RE: 51 Sewall Street

Your application to expand parking lot from 52 to 76 vehicles has been reviewed and a permit is herewith issued subject to the following requirements:

RHEUMATOLOGY ASSOCIATES 51 SEWALL STREET, PORTLAND, MAINE
 PARKING LOT IMPROVEMENTS
 TERPILLEN ARCHITECTS 300 MAINE SAVINGS PLAZA, PORTLAND, MAINE 1" = 20' - 0" 10.16.89

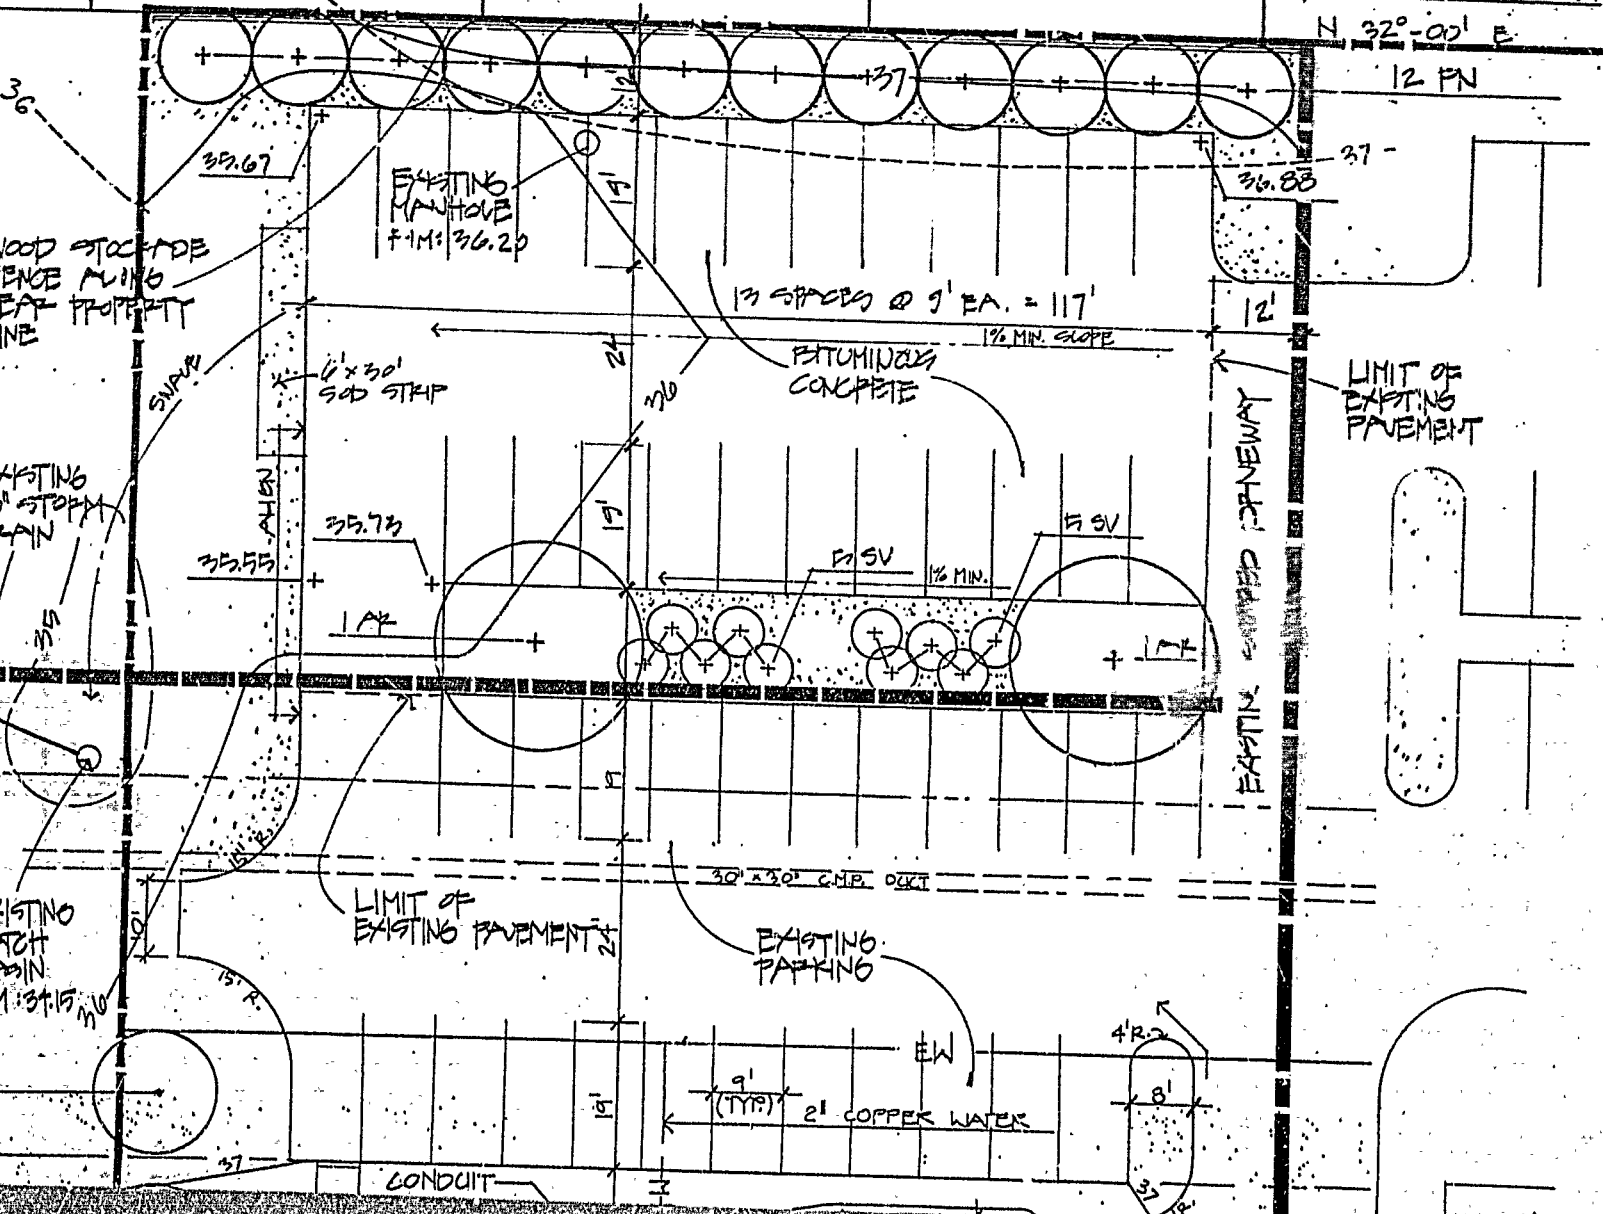
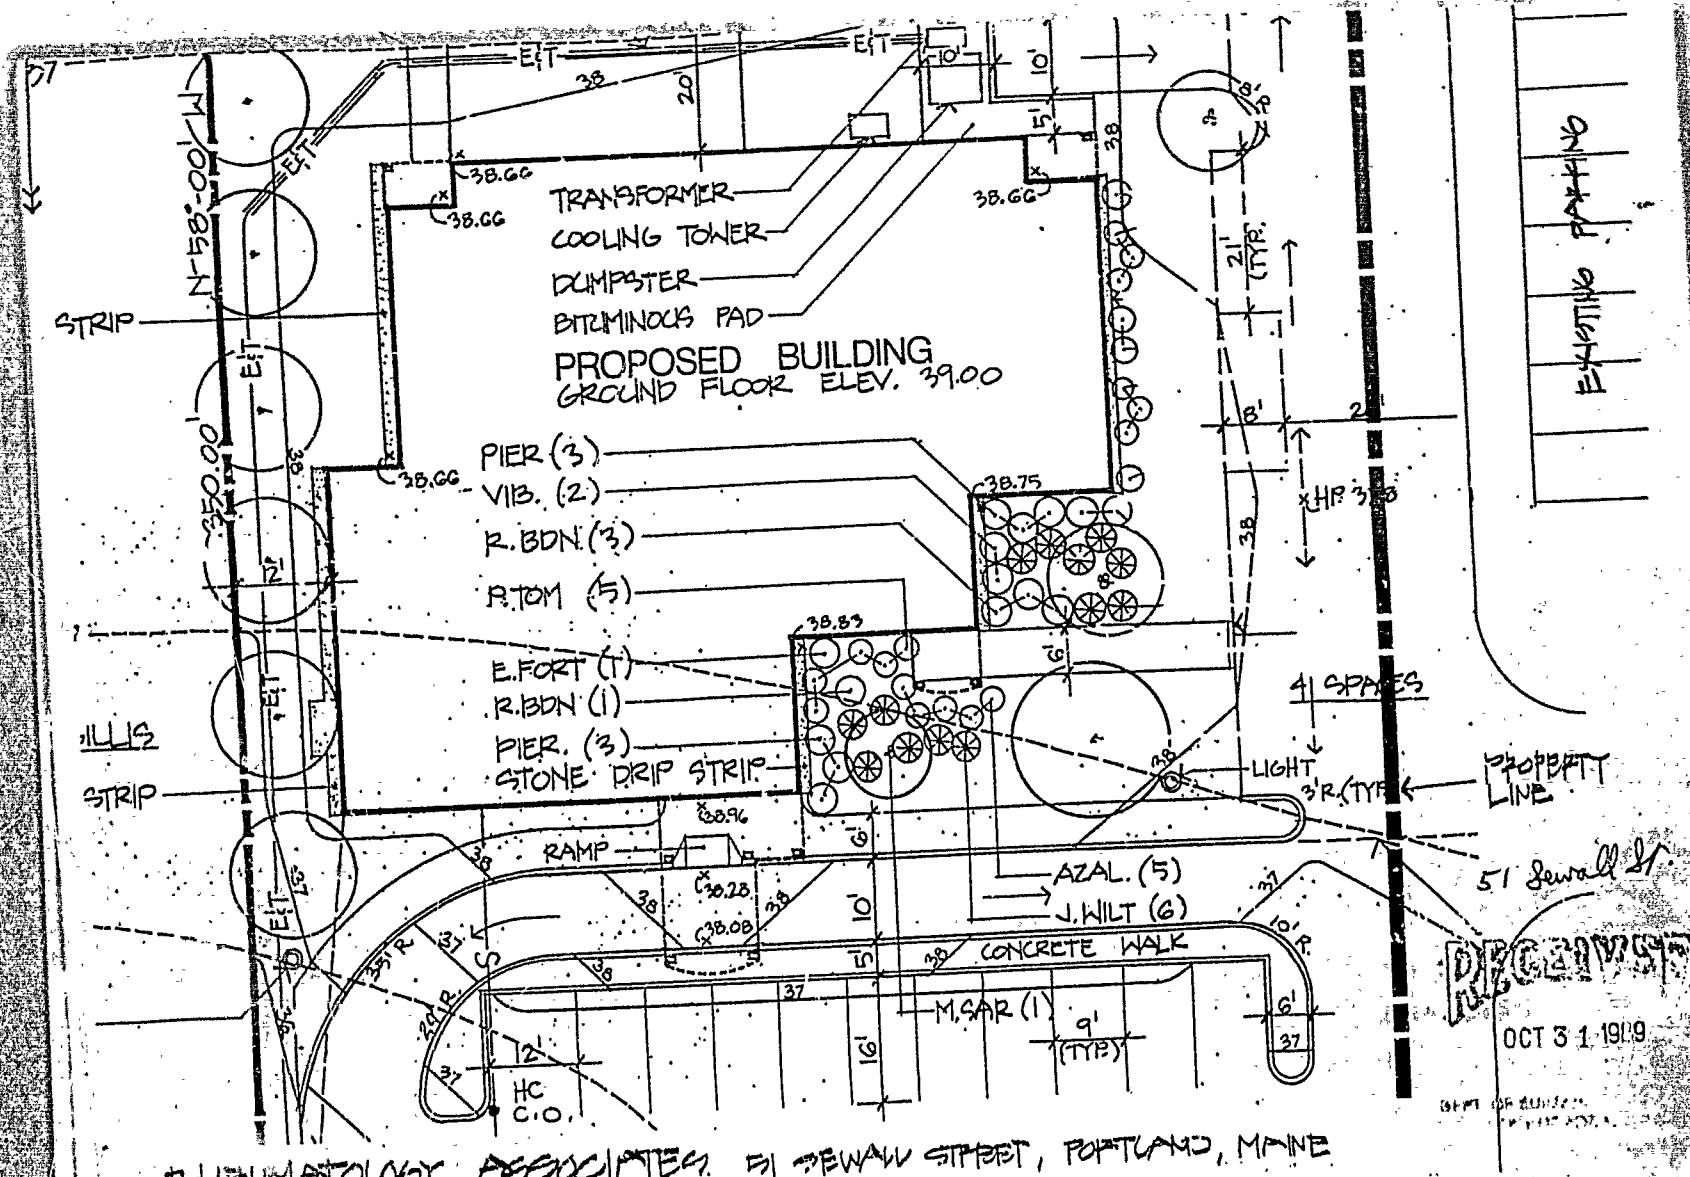
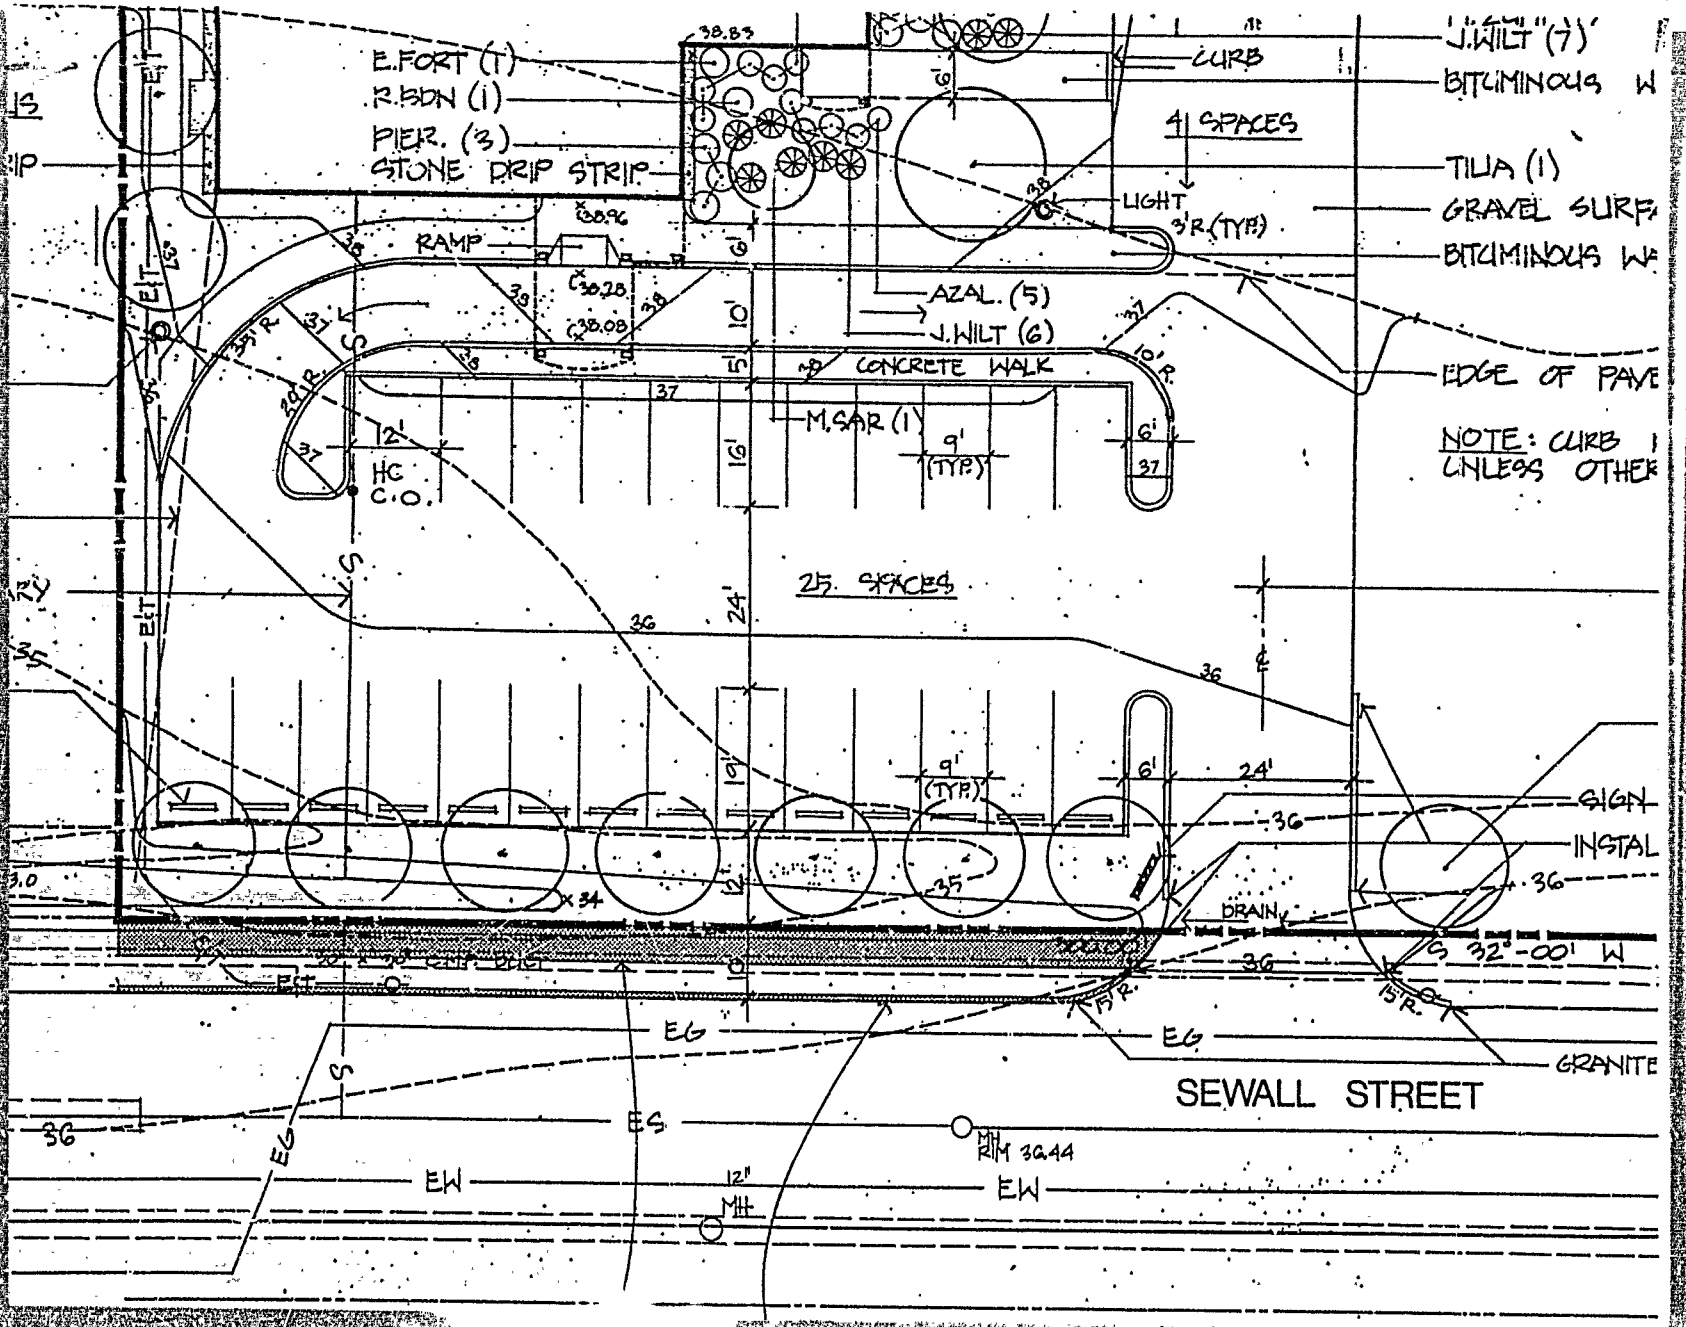
REASONS: 10' wide zone at head of bldg required to 16' min.
There must be a hydrant located within 80'
of the building measured along the path of travel
of fire apparatus.
 (Attach Separate Sheet if Necessary)

Handicapped parking spaces shall be provided as per State Law.
